# Technical Service Information

## THM 440-T4 LUBE DAM BROKEN

Figure 1

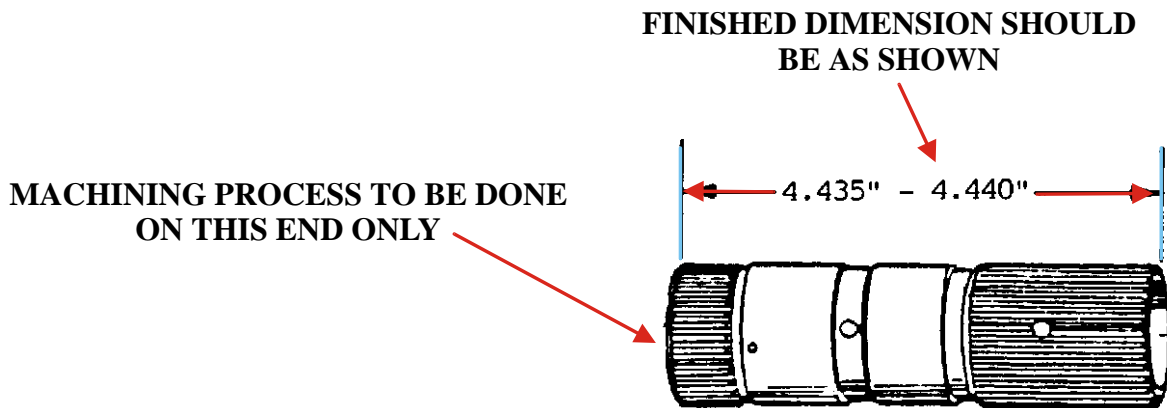
**CAUSE:** Final drive sun gear shaft is too long, and cuts plastic lube dam in half.

**CORRECTION:** Machine final drive sun gear shaft, ON THE SHORT SPLINED END ONLY, to the dimension shown in Figure 1. Finished dimension should be 4.435" - 4.440". Non-machined final drive sun gear shaft will measure 4.480" - 4.490". Measure all final drive sun gear shafts to insure proper length.

Figure 2

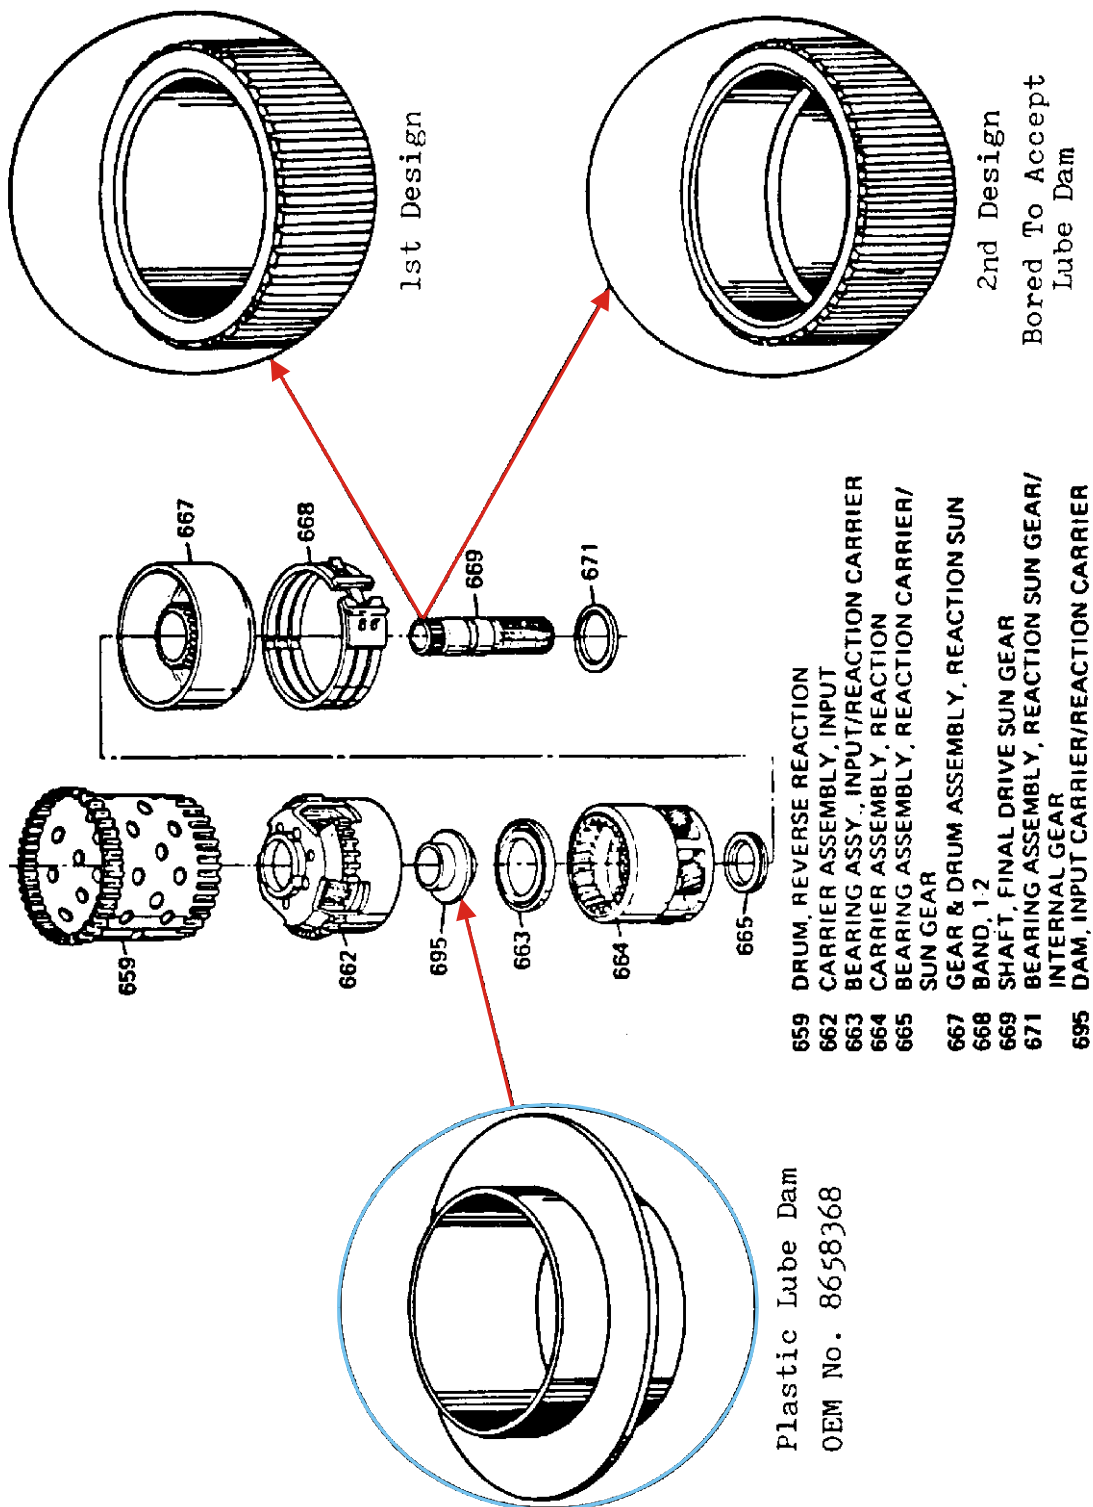
**COMPLAINT:** Plastic lube dam located between the carriers (See Figure 2) in two pieces, appearing as if it had been machined.
